31 May 2023

Job No. 21-13556

Subject: **Addendum to the Report of Preliminary Geotechnical Investigation and Geologic Fault Investigation and Response to the City of San Diego Geotechnical Review**
Proposed Javaheri Residence
2072 Via Casa Alta
La Jolla, California

Figure No. II
Job No. 21-13556

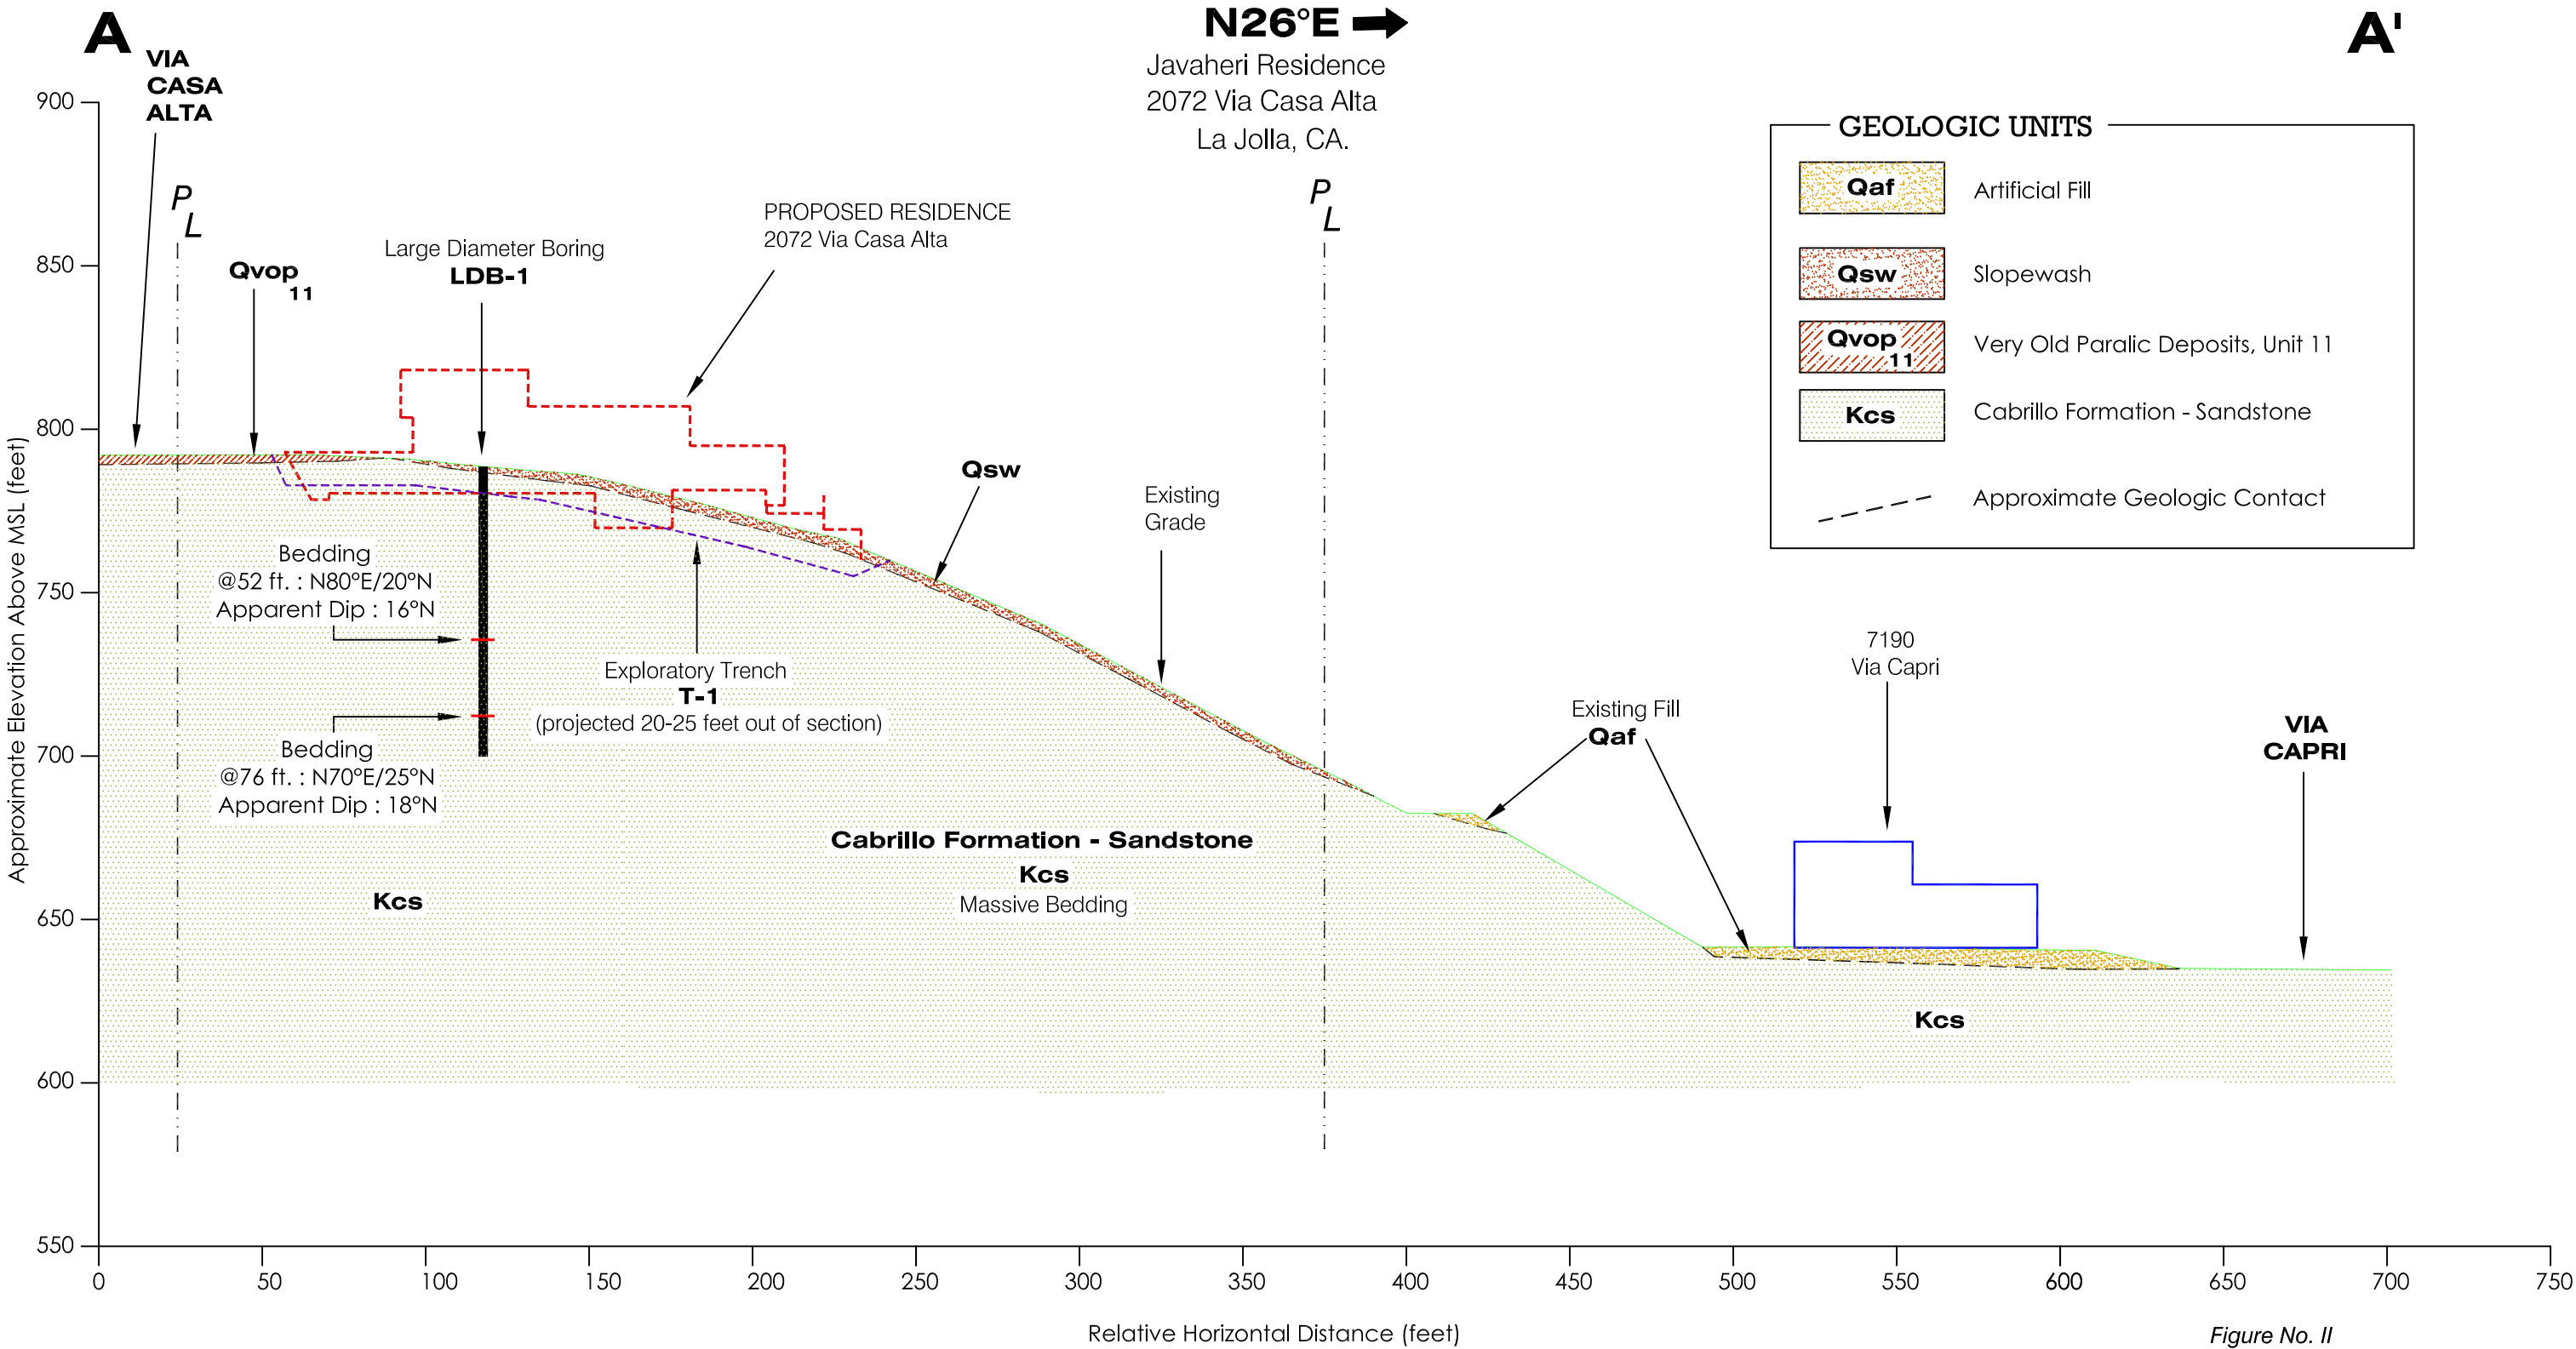
Issue No. 9: *Demonstrate the site will have a factor of safety of 1.5 or greater with respect to gross and surficial slope stability following completion of the project. Provide slope stability analyses consistent with the geologic cross sections. (From Cycle 2)*

Issue No. 22: *Provide an updated representative geologic/geotechnical cross section that shows the geologic structure, bedding, and/or apparent dips as documented in the subsurface exploration logs. (New Issue)*

Response: We are providing a slope stability analysis based on cross section A-A' through the site. Based on our revised gross and surficial slope stability analysis, the site has a factor of safety of 1.5 or greater and a factor of safety of at least 1.15 in seismic loading analysis. Refer to attached Figure Nos. I and II for the geologic cross section through the site and Appendix A for slope stability analysis.

Response: Attached as Figure No. II is an updated representative geologic/geotechnical cross section that shows the geologic structure, bedding, and/or apparent dips as documented in the subsurface exploration logs.

Javaheri Residence
2072 Via Casa Alta
La Jolla, CA.
Figure No. III
Job No. 21-13556

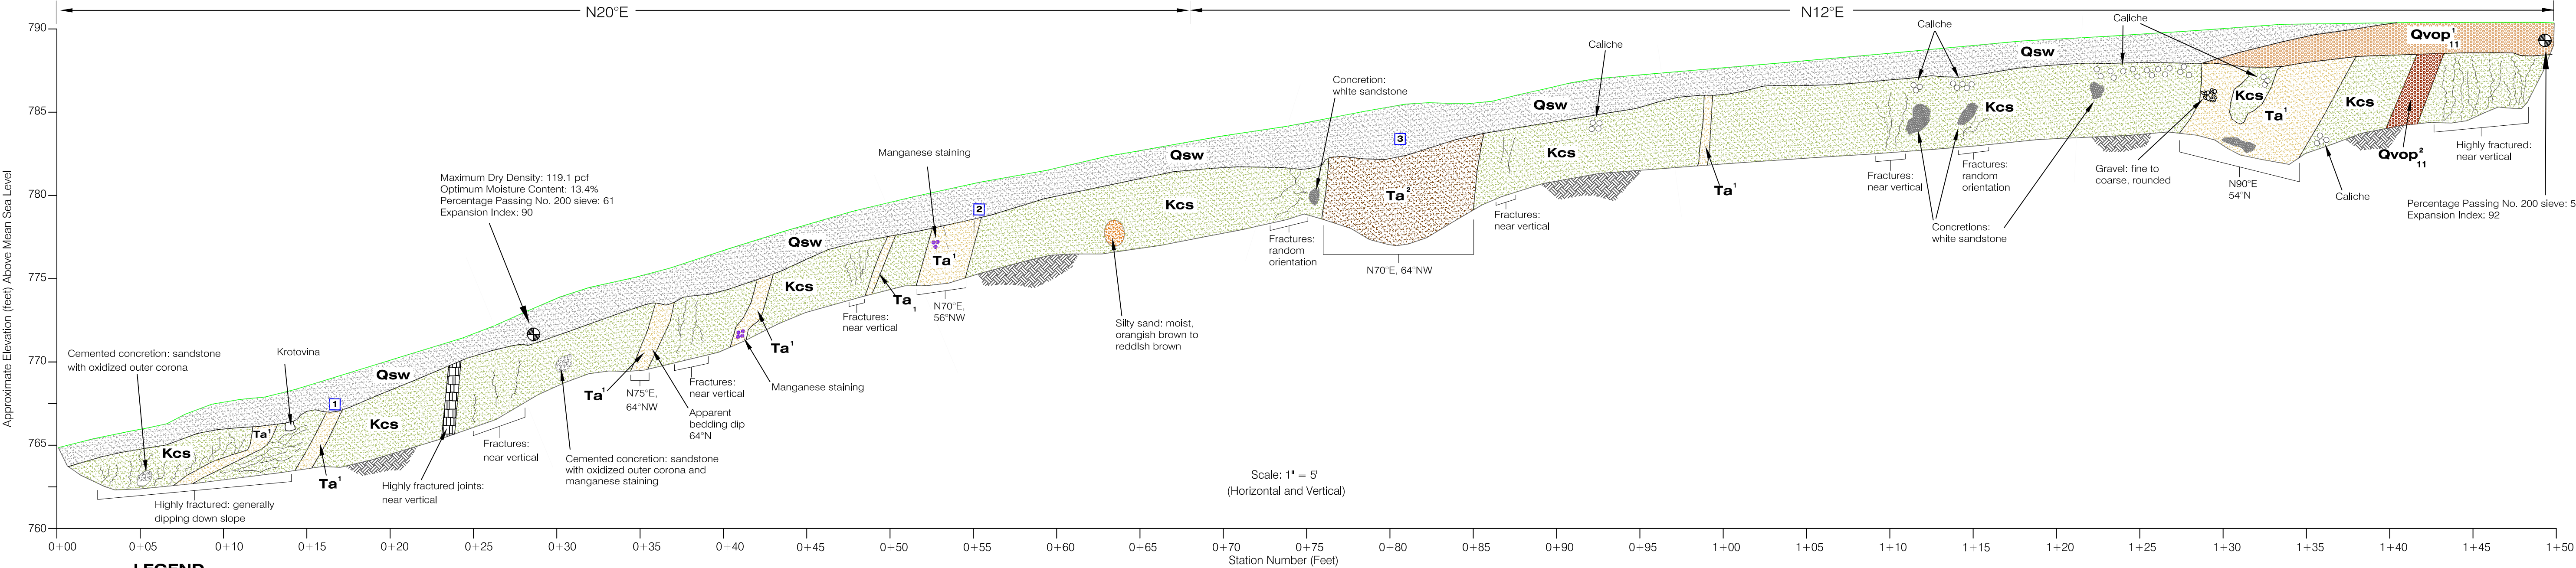
Issue No. 23: *Provide a revised Exploratory Trench T-1 log and remove all references to Geologic Cross-Section A-A'. Those references appear to be inaccurate and are confusing. The project's geotechnical consultant could consider simply labeling the trench limits with North and South. (New Issue)*

Response: Attached as Figure No. III is a revised Exploratory Trench T-1 log with north and south labeling and no reference to geologic cross section A-A'.
